C-900 - ADDENDUM

Addendum No. 3

Date:	<u>March 29, 2019</u>
Issued To:	<u>Plan Holders</u>
From:	<u>Alan Plummer Associates</u>
Project:	<u>Wastewater Treatment Plant Expansion</u>

YARD PIPING PLAN

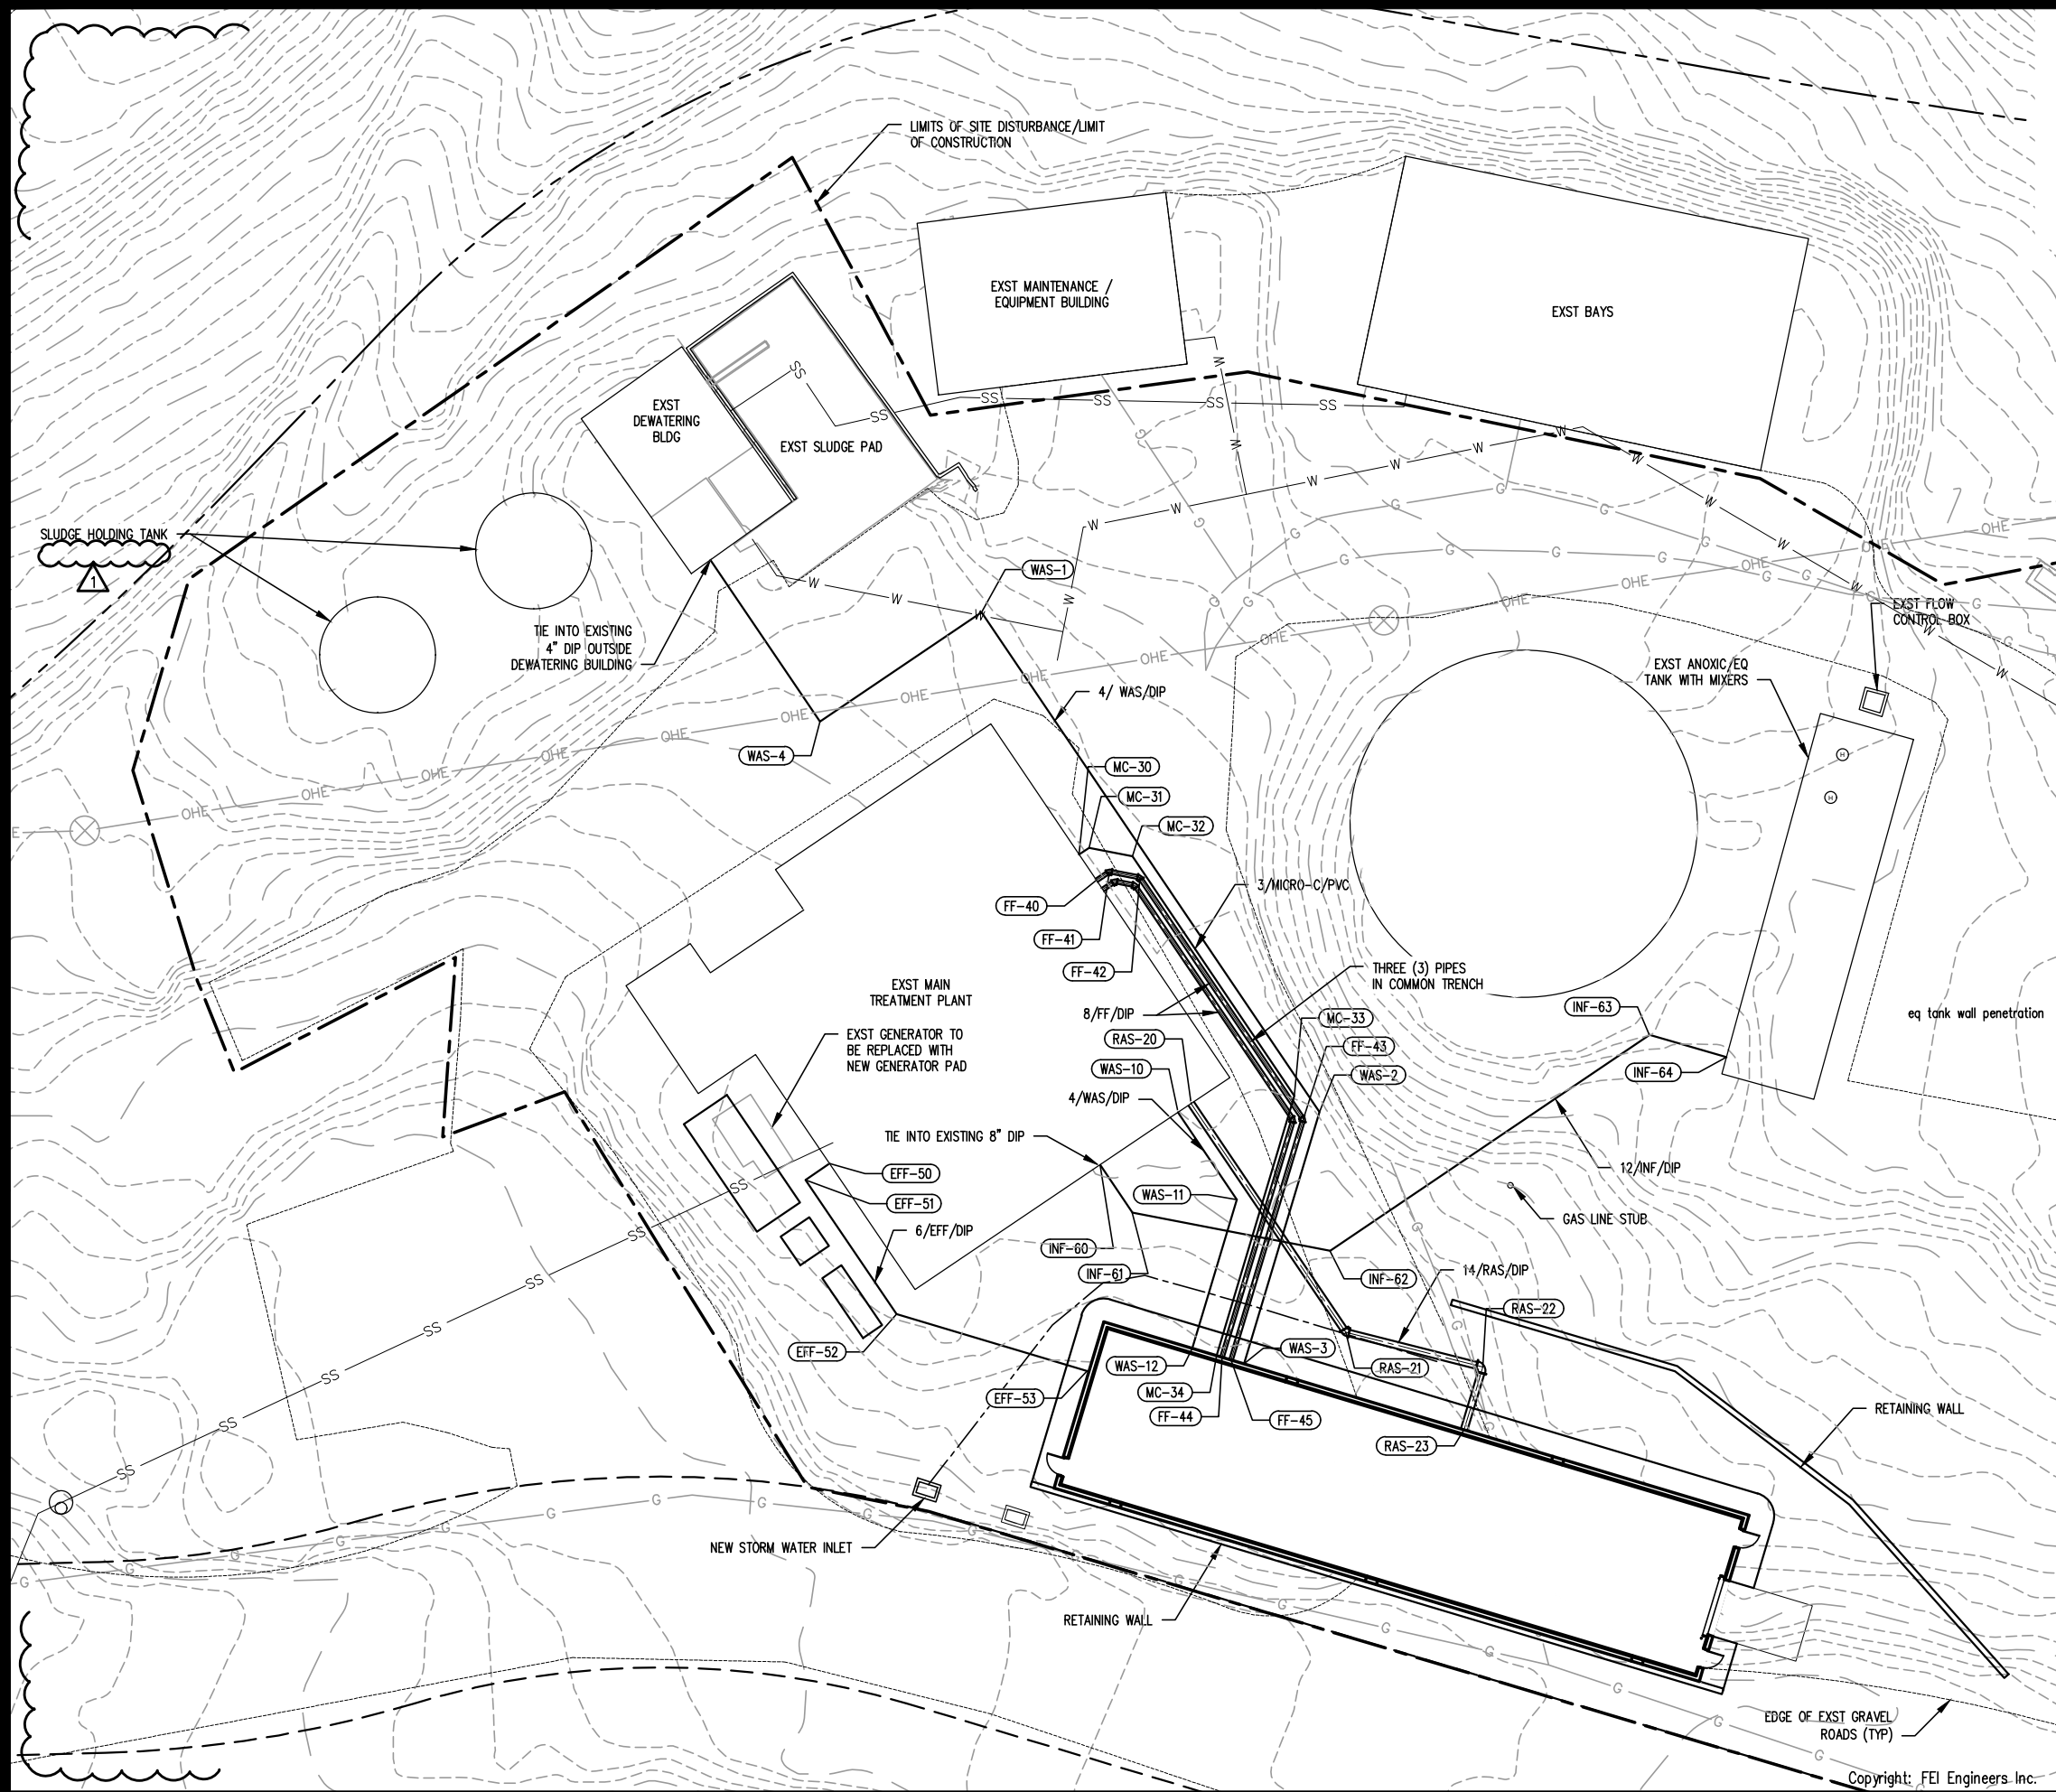
- A. Plan Sheet C1-03 & 4: Could point info (N/E, & Inv. Elev.) be provided where the 8" Feed Forward Lines enter the New treatment Bldg.
 - 1. Response: Refer to revisions for Sheet No.'s C1-04 and C1-05 included in this Addendum.

- B. Plan Sheet C1-04 & 5: Could point info (N/E, & Inv. Elev.) be provided where the 14" RAS Line Riser leaves the New Treatment Bldg?
 - 1. Response: Refer to revisions for Sheet No.'s C1-04 and C1-05 included in this Addendum.

- C. Plan Sheet C1-04 & 5: Could point info (N/E, & Inv. Elev.) be provided where the (2) 4" WAS Lines leave the New Treatment Bldg?
 - 1. Response: Response: Refer to revisions for Sheet No.'s C1-04 and C1-05 included in this Addendum.

- D. What is scale on C1-04?
 - 1. Response: The scale for Sheet No. C1-04 is 1" = 30'. Refer to revisions for Sheet No. C1-04 included below in this Addendum.

OVERALL SITE GRADING PLAN

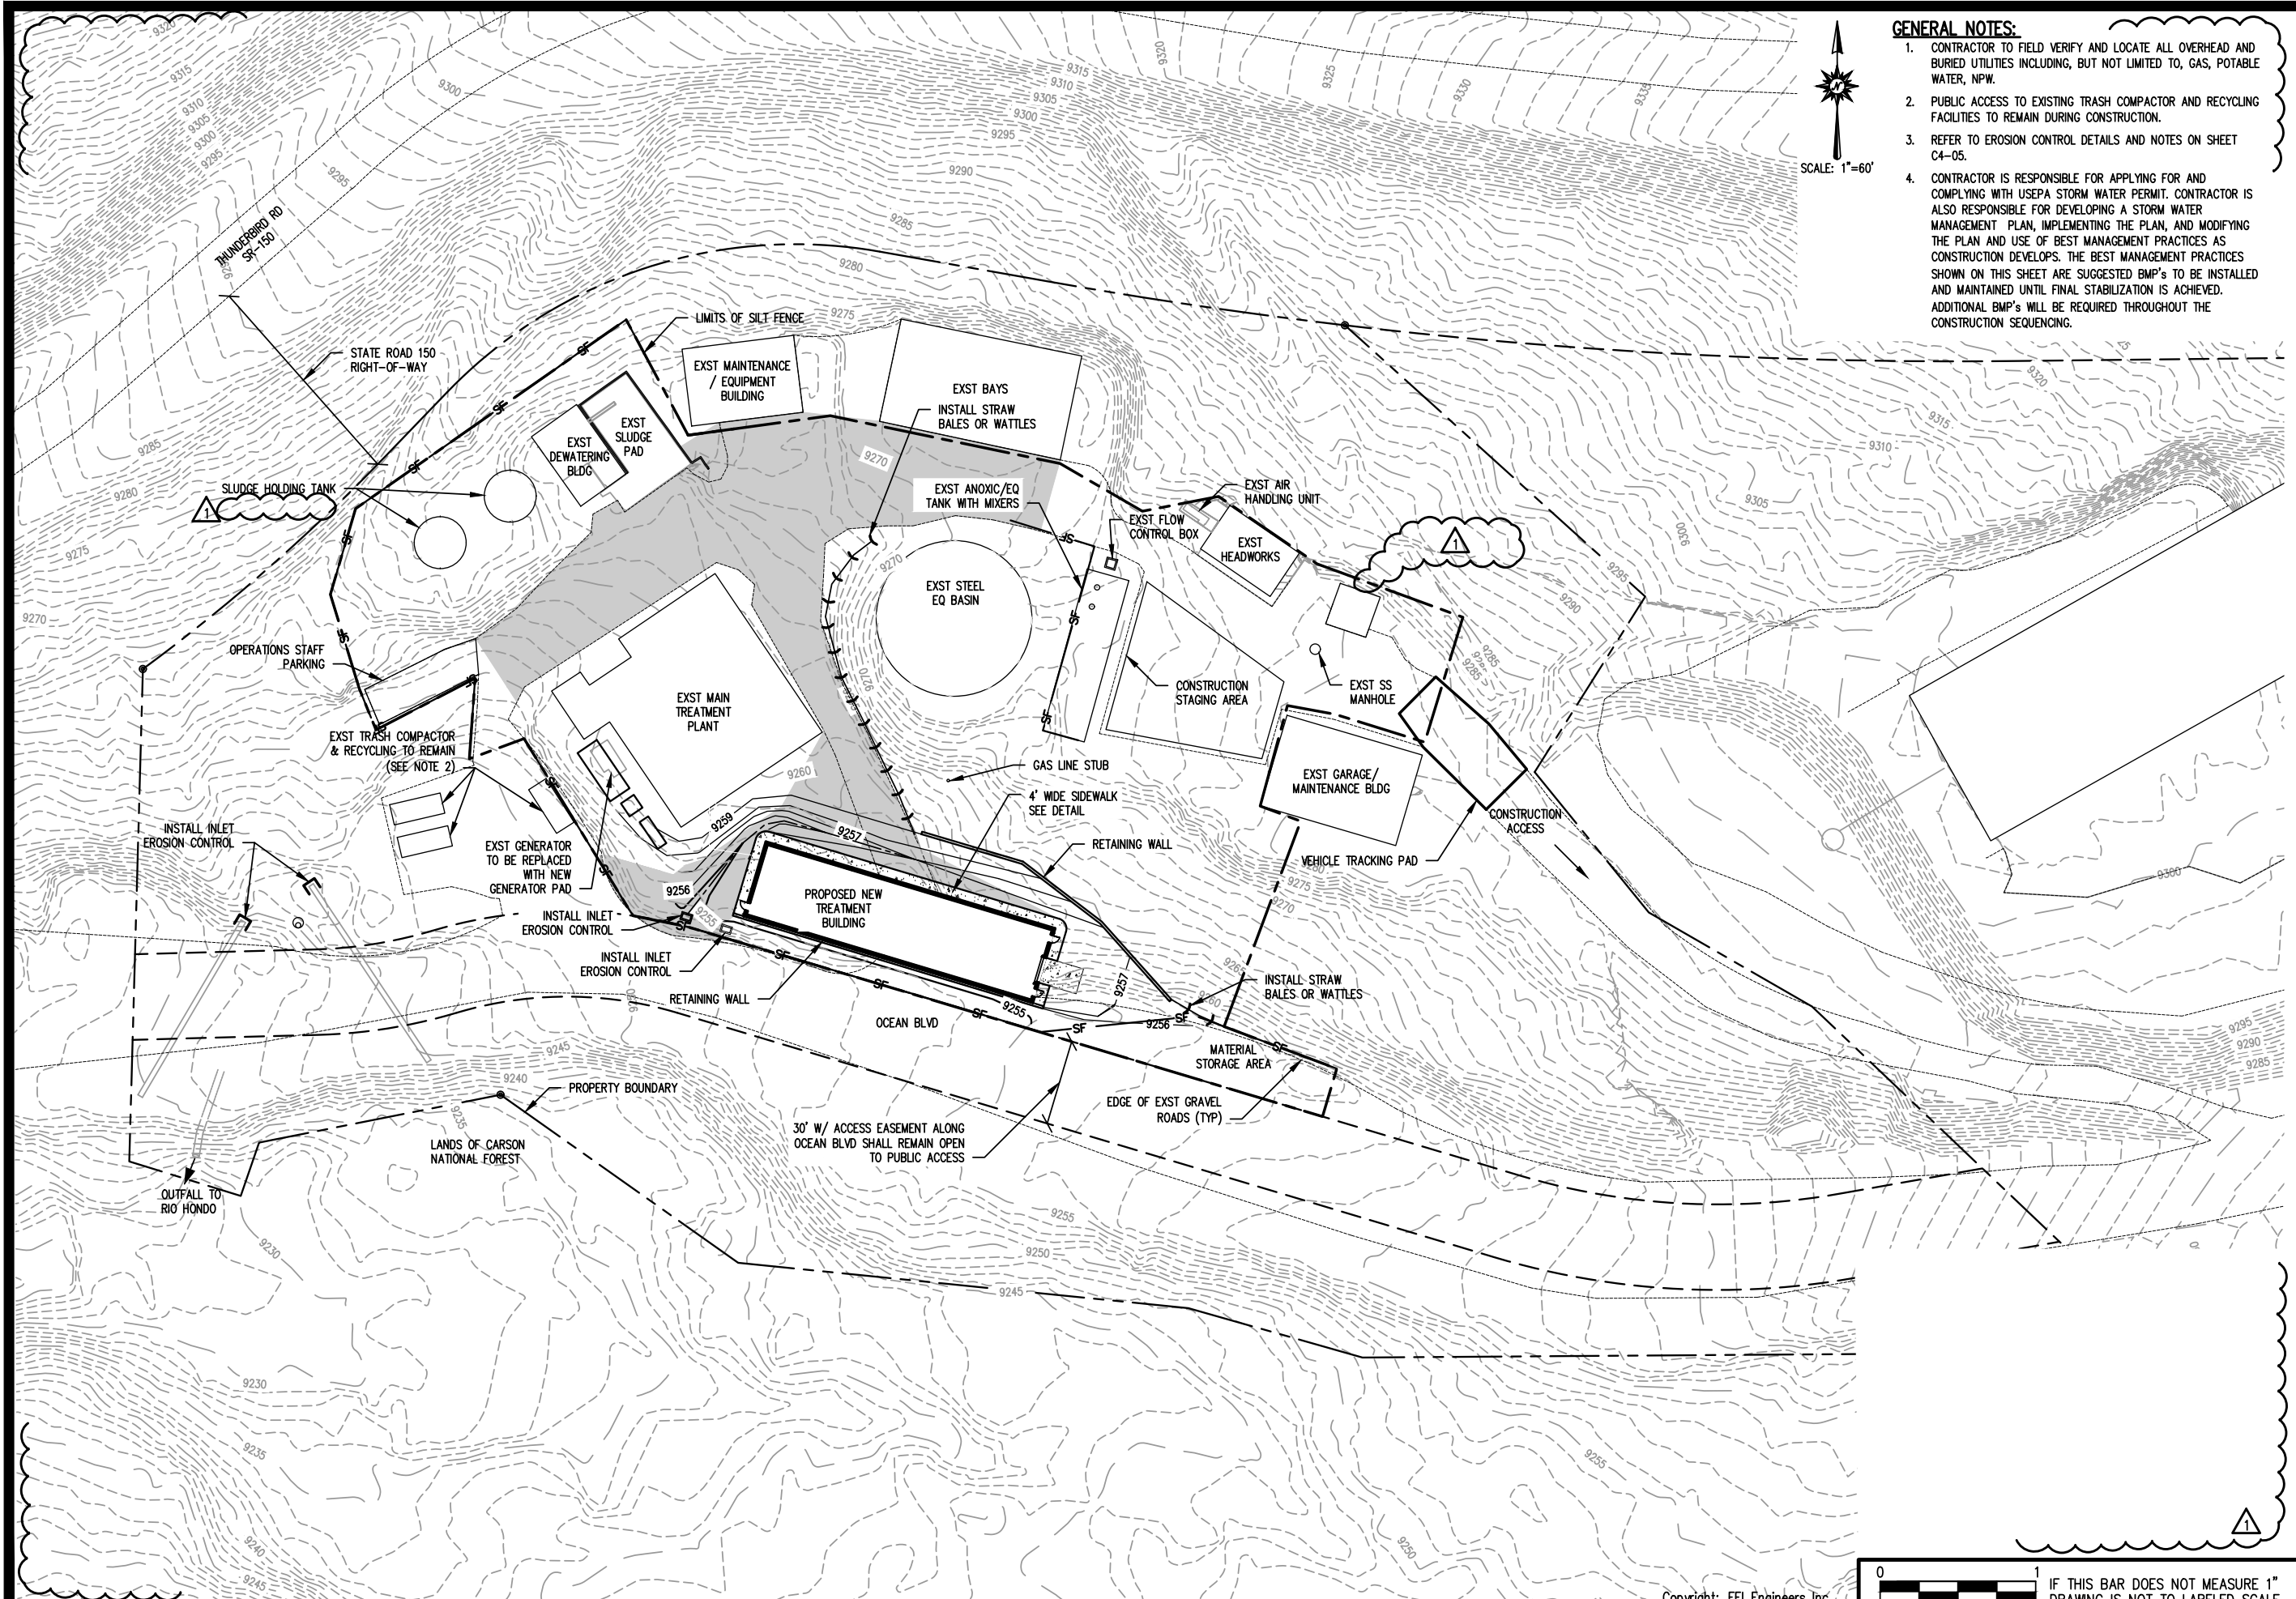
1. Response: Yes, the existing dewatering system is to be used for processing the sludge. Please also refer to Response to Question T, Addendum No. 1.
- T. Please provide bottom of footer and top of wall elevations for the retaining wall NE of the new building.

1. Response: Refer to revised Sheet No. C1-06 for retaining wall top of wall elevations. Refer to Structural Sheet No. S1-03 Retaining Wall Typical Section for bottom of footer elevations.
